March 16, 2009

RE: Cooper Tire & Rubber Company - Texarkana, Arkansas,
NPDES Permit No. AR0038822
Draft Permit

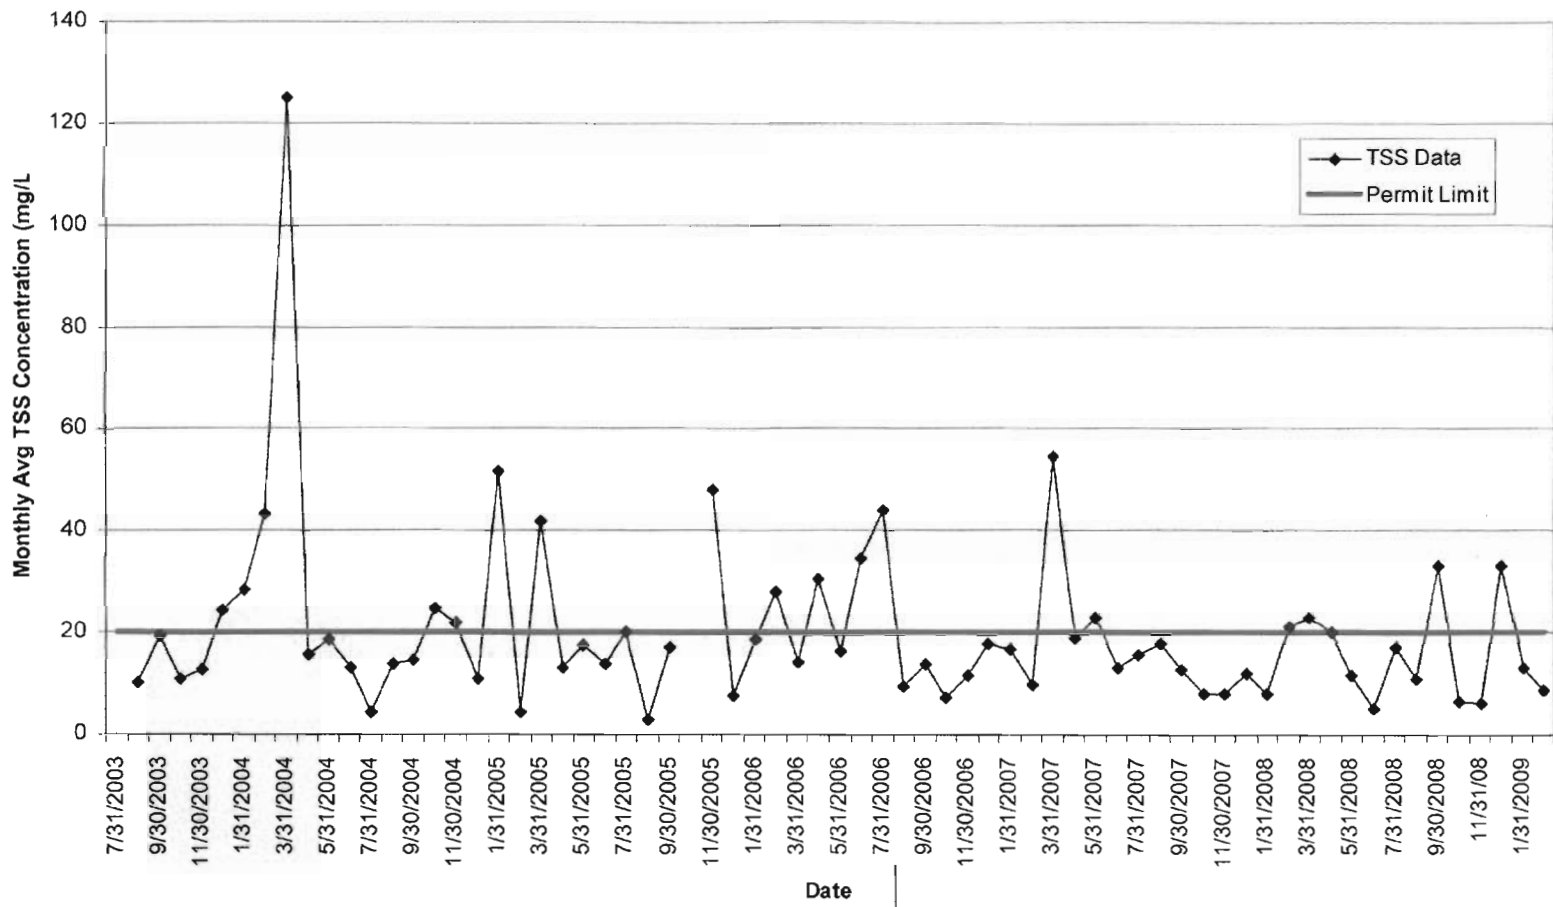
Cooper Tire TSS DMR Data

13 violations
July 2003 - July 2006

BAT
fully
implemented

6 violations
Aug 2006 - Jan 2009
